Appendix C – Designers Response

LAND NORTHWEST OF SOUTHWATER

Stage 1 Road Safety Audit Designers Response

DRAWING No:	UK0043490.9681-WSP-XX-XX-DR-C-0003	REV:	P01
-------------	------------------------------------	------	-----

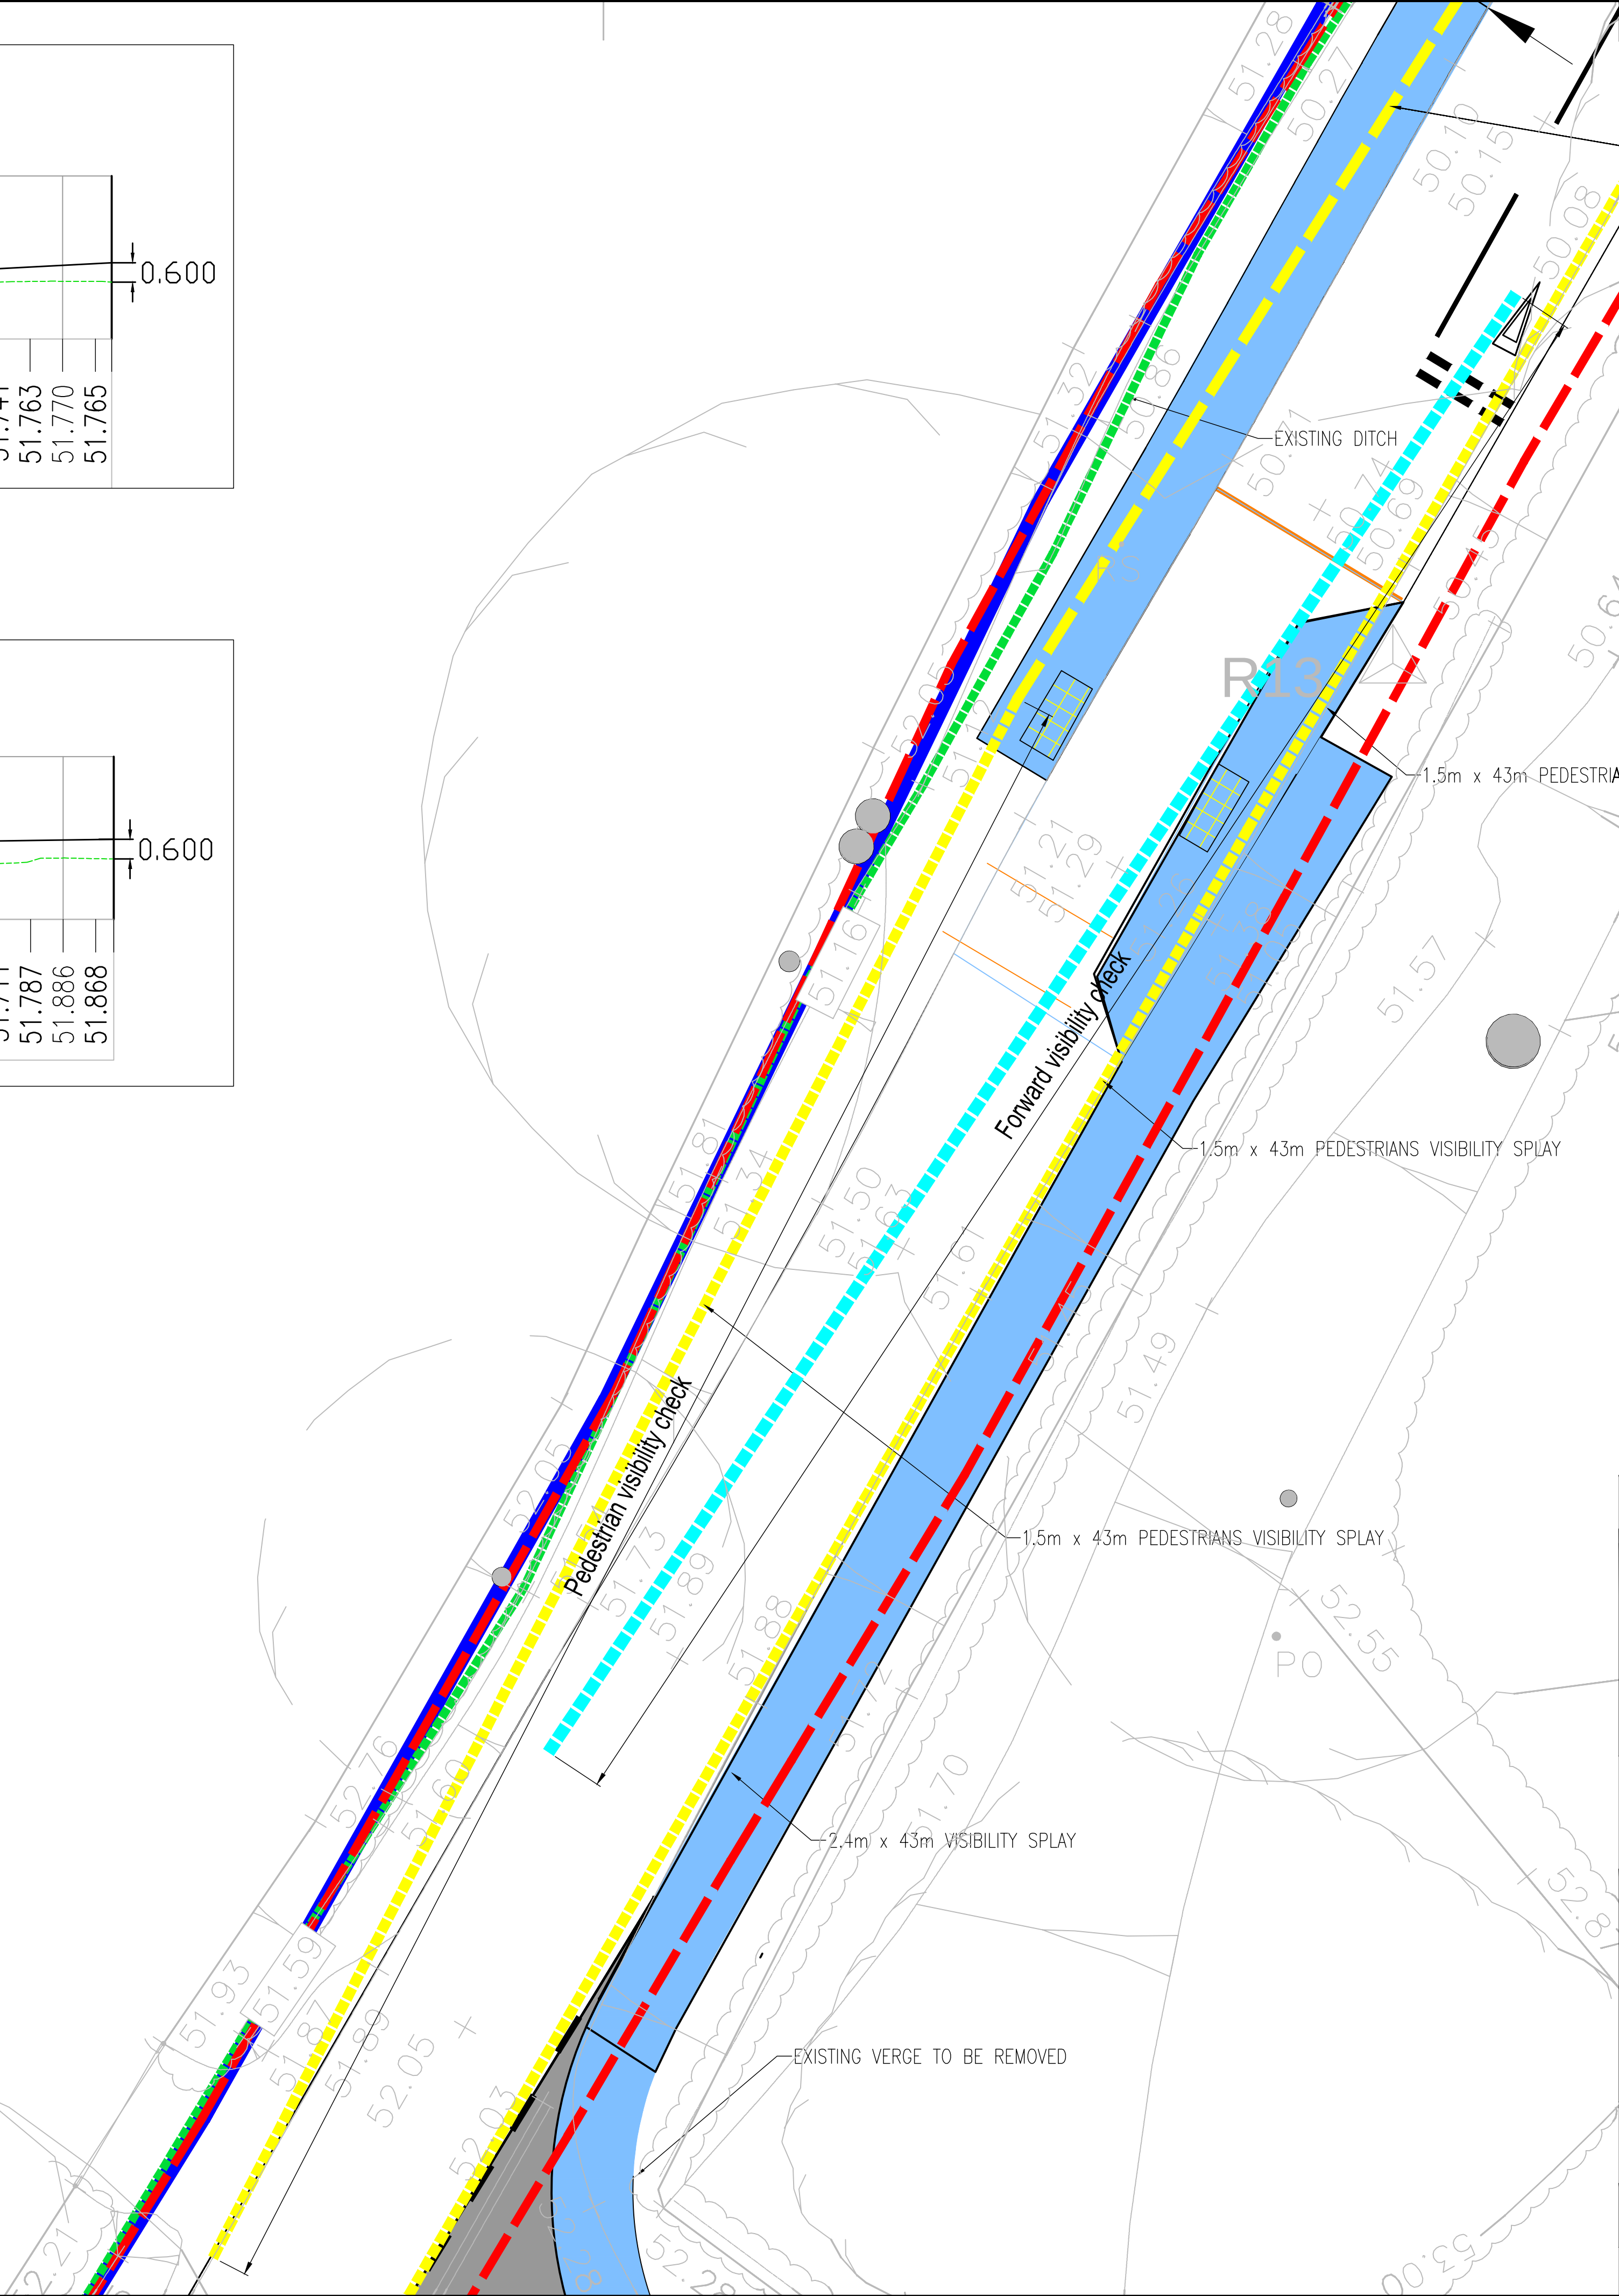
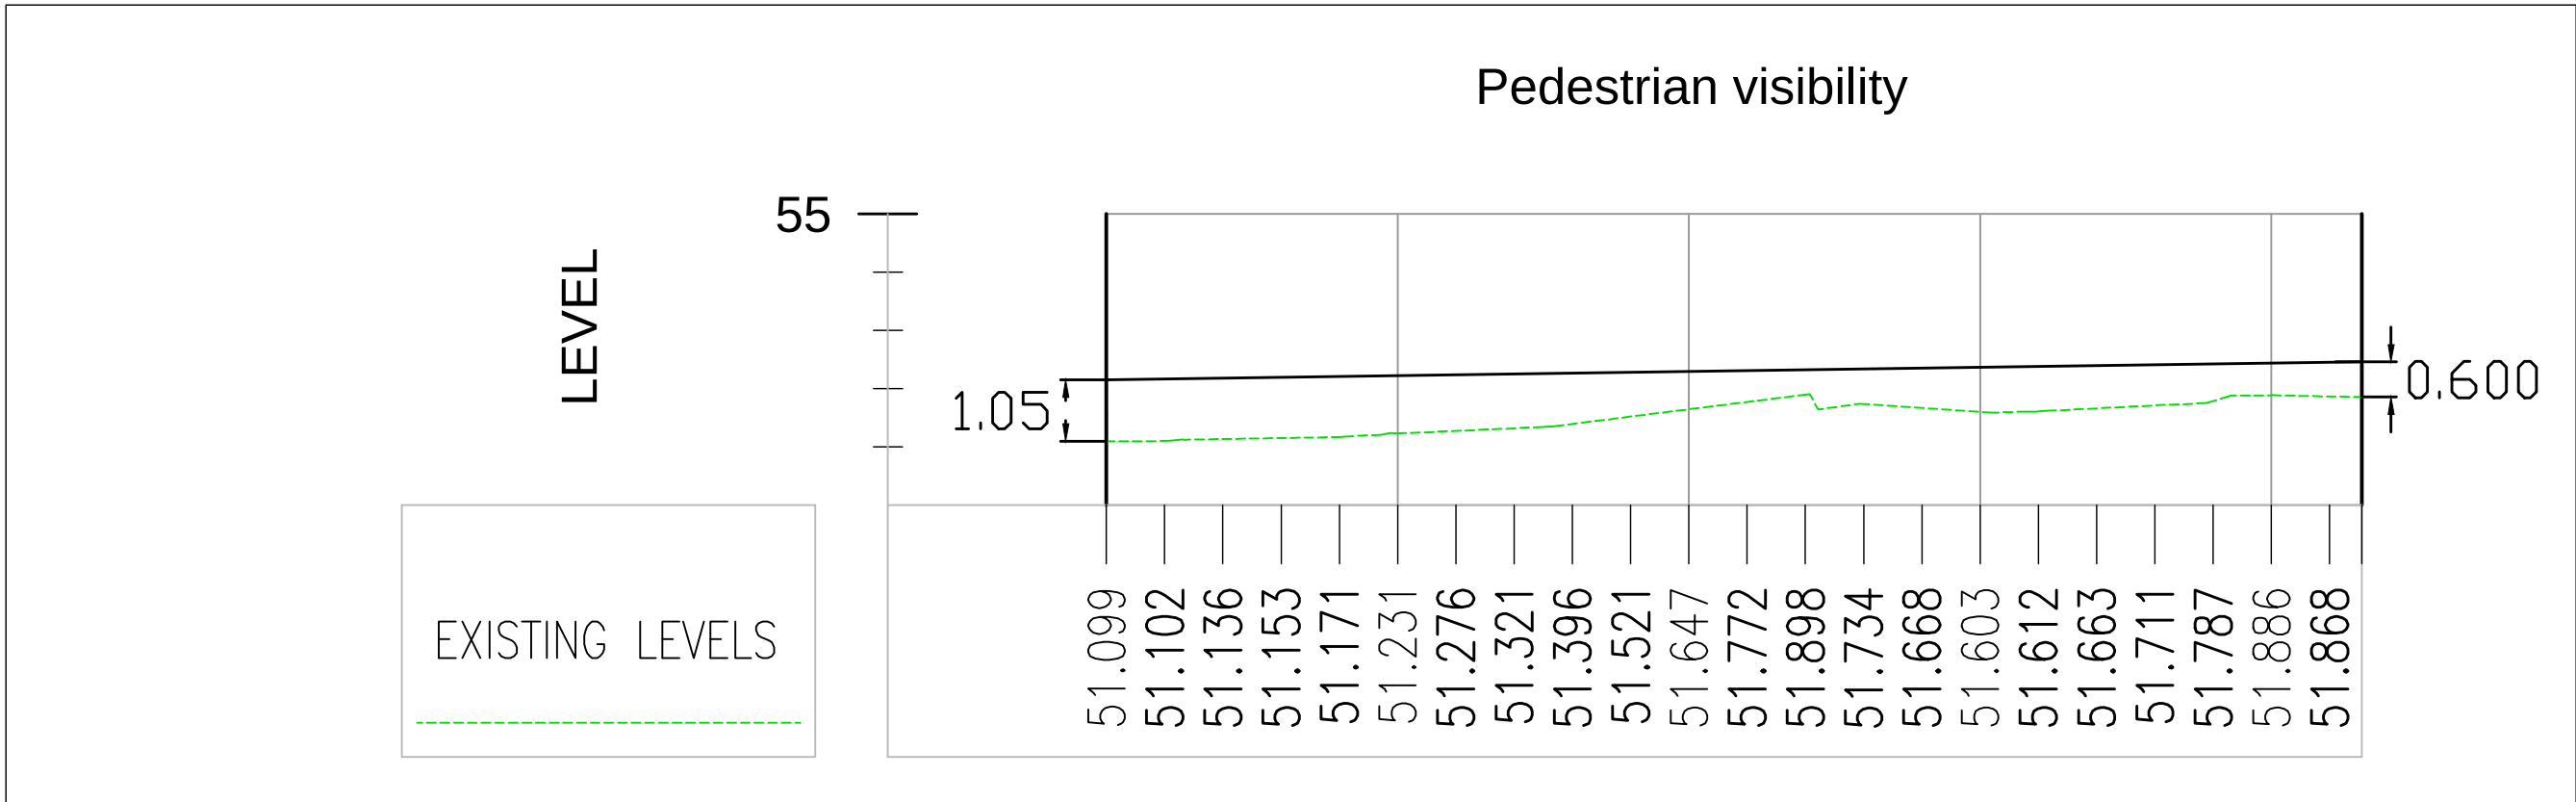
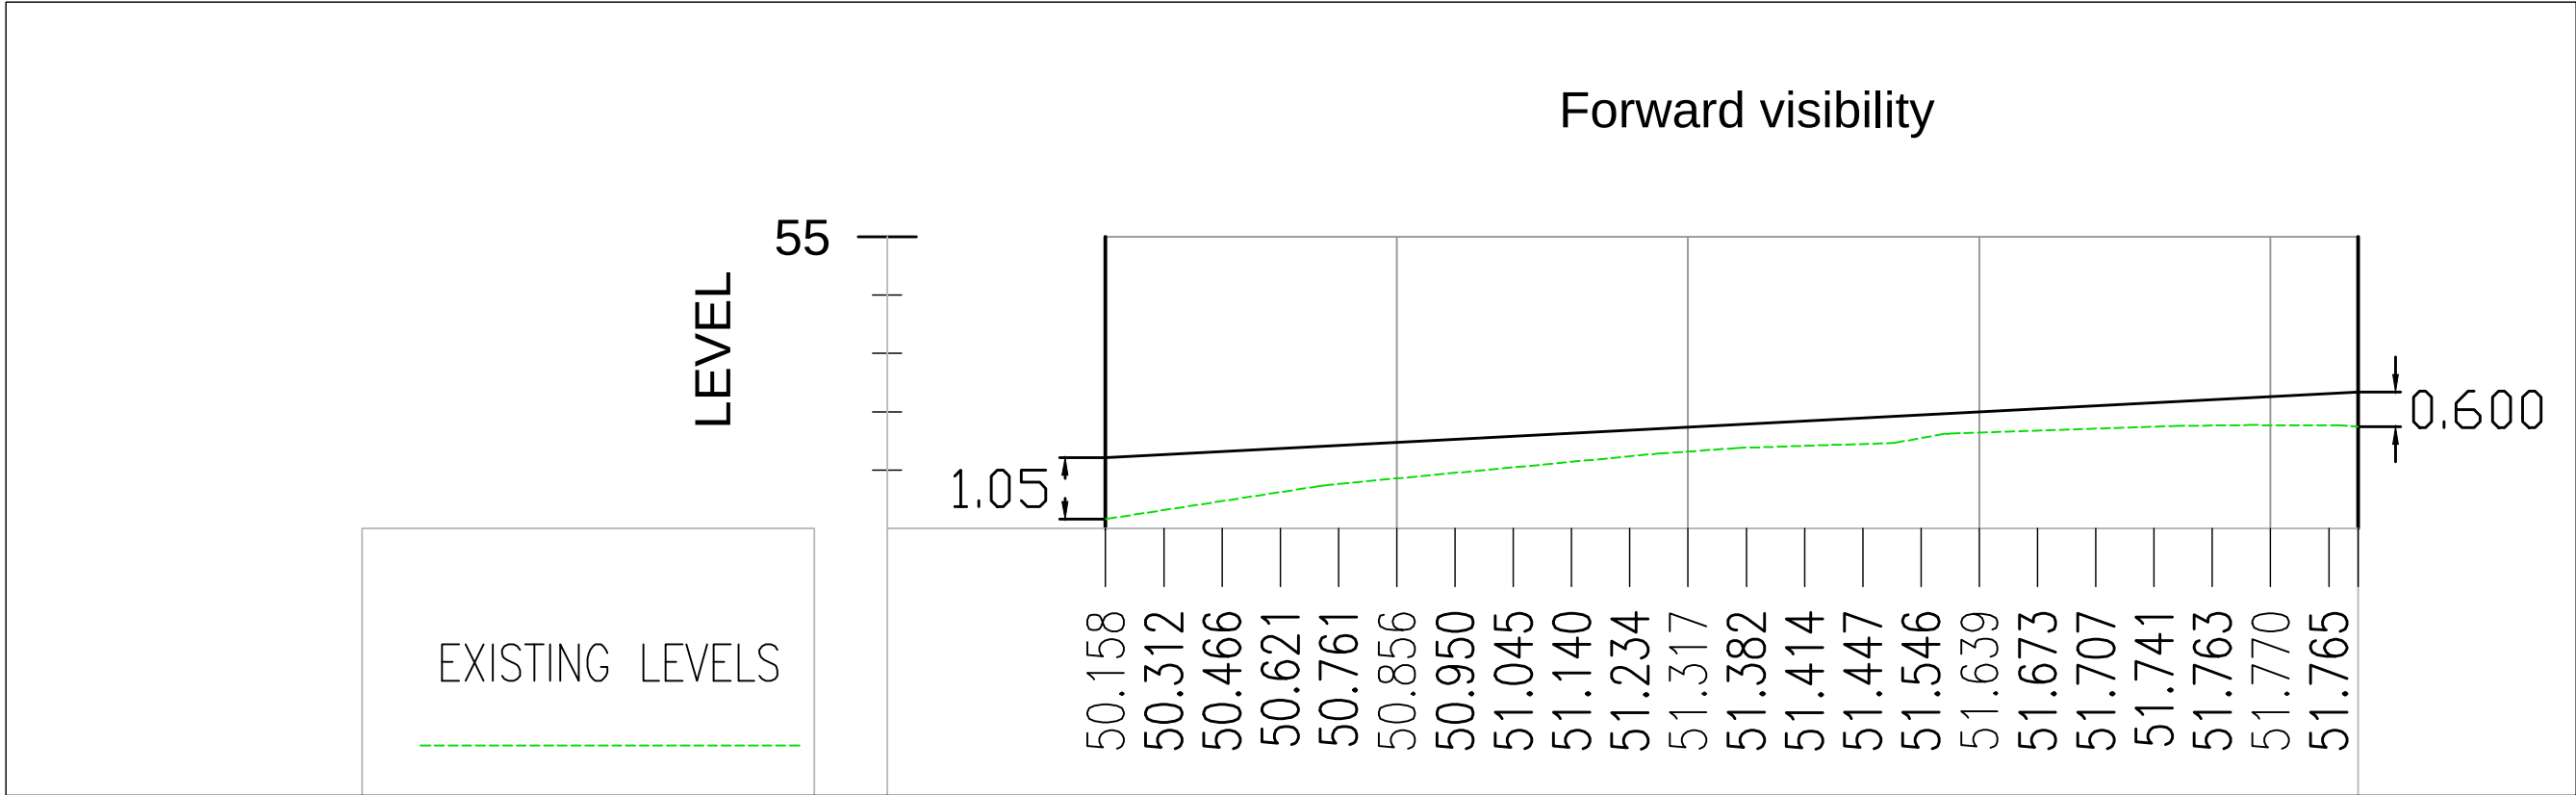
RSA Problem & Paragraph No.	RSA recommendation	Design organisation response	Overseeing Organisation response	Agreed RSA action
Problem 1 Location: Two Mile Ash Road, southern-most section adjacent to Access 4. Summary: Increased risk of vehicle to vehicle head-on or vehicle to pedestrian type collisions. A buildout incorporating an uncontrolled crossing facility is proposed to the north of Access 4. The site visit has established that there is an existing carriageway crest to the south of this proposed measure. This reduces driver intervisibility between northbound drivers and those manoeuvring around the buildout feature with an increased risk of vehicle to vehicle head-on type collisions. Further, pedestrians using this crossing facility may not be seen by northbound drivers with a risk of vehicle to pedestrian type collisions.	The Audit Team recommend that the buildout is sited such that sufficient intervisibility is provided and that pedestrians can cross safely.	The design has been developed such that sufficient visibility can be provided. WSP Drawing xxx shows the vertical visibility splays to the crossing and to vehicles waiting.
